ECHOMASTER **Technical Bulletin**

Models Affected: EM-BUC-KIT-JW, EM-JP-CAM, FC-WRANGLER, FC-WRANGLERPRO, FC-WRANGLERPRO-RSC,

Alert Code: Medium

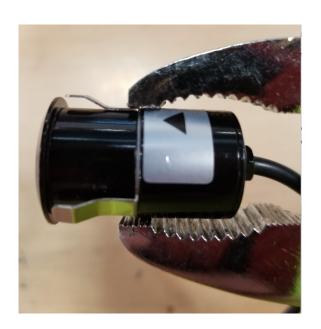
Stated Complaint: PCAM-220 not fitting into the JP-MOUNT or difficulty inserting the camera into the mount.

Cause: It has been found that the spring clips located on the PCAM-220 camera housing may have incorrect bends. These bends cause the diameter of the PCAM-220 camera to exceed diameter of the mounting hole of the JP-MOUNT, resulting in difficulty inserting the PCAM-220 into the JP-MOUNT.

Solution: Using a set of Channel Locks or Pliers, compress the three clips located on the camera to be flush with body of camera. Please refer to pictures below for reference.

Using a set of Channel Locks or Pliers, position the tool on the clip as shown above and squeeze to compress the clip. Repeat this for all three clips located on the PCAM-220 camera.

Once completed the clips should be flush with the PCAM-220 body. This will allow the camera to slide into the mounting hole of the JP-MOUNT.
